# UNITED STATES PATENT AND TRADEMARK OFFICE

APPLICATION NO.	FILING DATE	FIRST NAMED INVENTOR	ATTORNEY DOCKET NO.	CONFIRMATION NO.
09/362,808	07/28/1999	HONGYONG ZHANG	07977/088002	7320

<b>Office Action Summary</b>	Application No.	Applicant(s)	
	09/362,808	ZHANG, HONGYONG	
	Examiner	Art Unit	
	Steven H. Rao	2814

### ***Response to Amendment***

FIG. 6

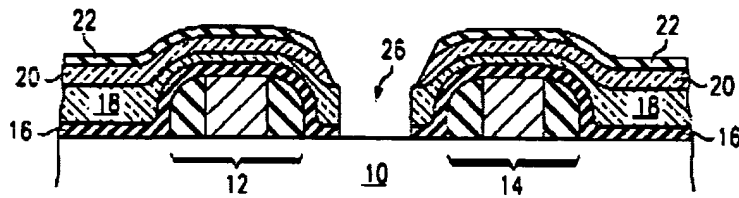
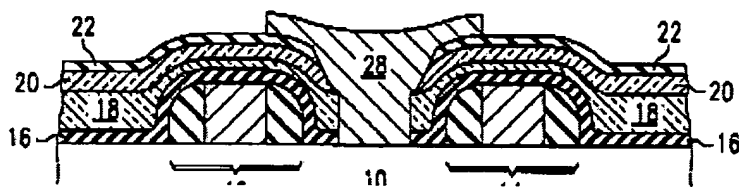
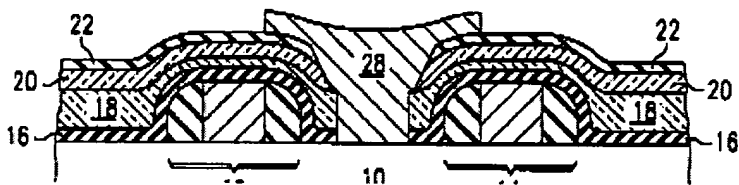
It can be clearly seen that layers 16/18 and 20/22 have first and second interlayer insulating films including a contact hole formed such that a taper angle 'Beta ' of an inner surface of the second interlayer insulating film in the contact hole with respect to a major surface of the semiconductor layer is larger than a taper angle  $\alpha$  of an inner surface of the first interlayer insulating film in the contact hole with respect to the major surface of the semiconductor layer. ( see below).

As seen above, clearly, when two sets of interlayer dielectric are taken together ( to equate ) the presently recited requirements of claim 14 the set 16/18 or 20/22 each taken individually renders the presently recited claim 14 obvious.

Applicants' attempt to include all four inter layers and conclude they are not smaller is a red herring and not commensurate in scope with the presently recited claims.

to 65. All of which make it clear that comparison must be made either layers 16/18 and applicants' claims or layers 20/22 and applicants' claims, and when the correct comparison is made (as opposed to Applicants' comparing Appeals and Oranges by comparing Lin's four layers together 16/18 and 20/22) applicants' arguments are not persuasive.
